R11SZ

**SUBJECT: RECALL R11SZ BRAKE ABS MALFUNCTION INDICATOR LIGHT
NONCOMPLIANCE**

Stoneridge Instrument Cluster ABS Malfunction Indicator Noncompliance

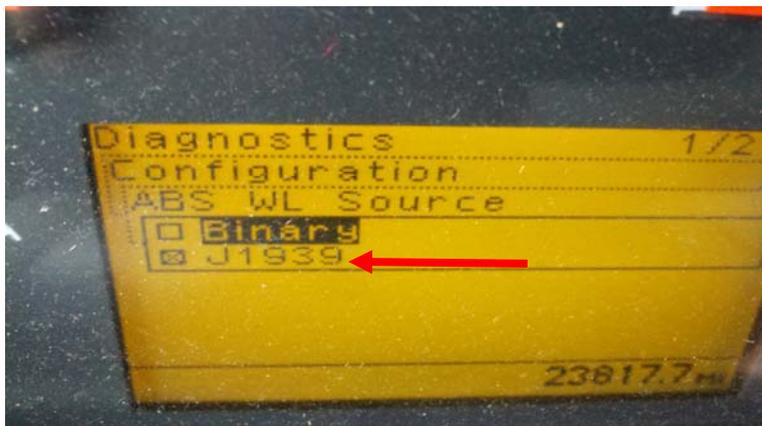
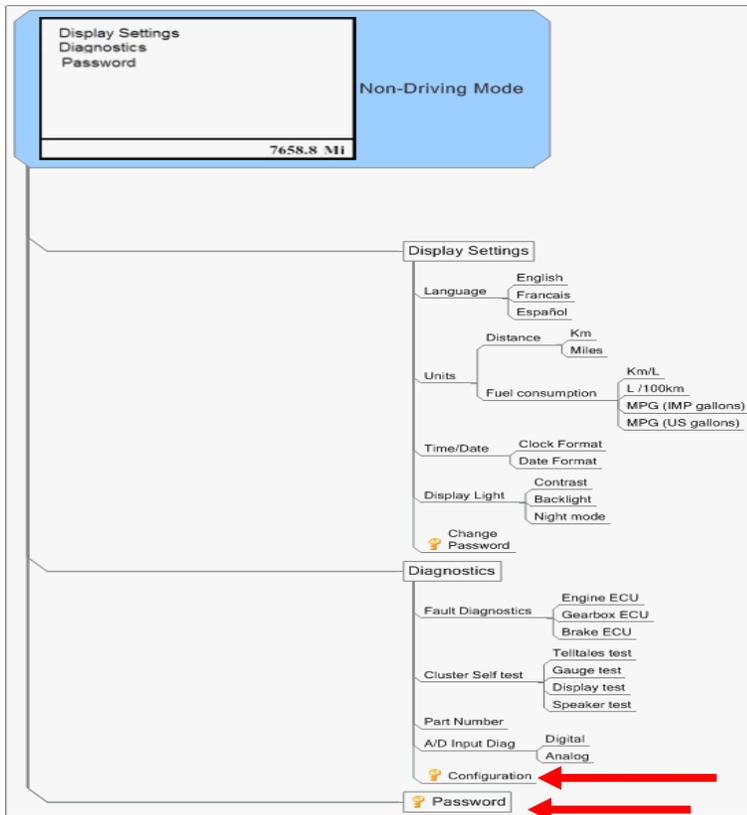
Step 12. Using steering column stalk switch and instrument cluster configuration menu verify the “ABS WL Source” is set for “J1939”. Access to the configuration option is protected and requires the user to provide the access code via the “**Password**” option to enable it. Enter the password “2290” first. It is necessary to execute an ignition cycle (OFF/ON), after revising desired parameters, for EE parameter changes to take effect.

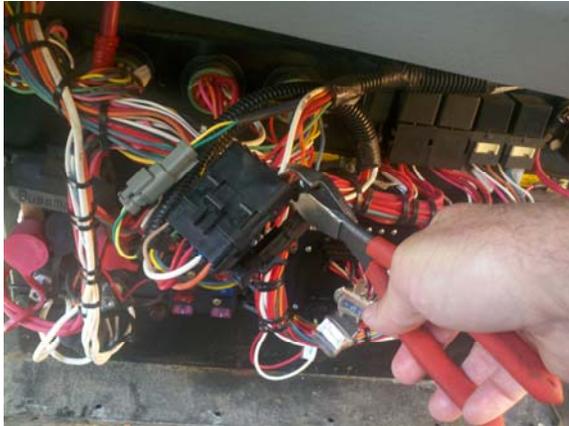
4. Locate connector C504 in PDU (detail shown below). Cut and remove connector C504 from the PDU and ABS harness.

5. Splice each circuit from previous step to the corresponding circuit. Use appropriate terminal as listed below.

C504	
ABS IGN (OR)	>A>	ABS IGN (OR)
ABS GND (WH)	>B>	ABS GND (WH)
ABS BAT (RD)	>C>	ABS BAT (RD)
MOD PMP BAT (RD)	>D>	MOD PMP BAT (RD)
ABS LGT (GN)	>E>	ABS LGT (TN)
ABS ACTIVE + (GN)	>F>	ABS ACTIVE + (TN)

Remove two “C504” connectors and splice each circuit to the corresponding circuit.

“ABS LGT”, “ABS ACTIVE”, circuit use terminal # 00005840.

“ABS GND”, “ABS BATT”, “MOD PUMP BATT”, circuit use terminal # 0036508.

“ABS IGN” circuit use terminal # 00036507.
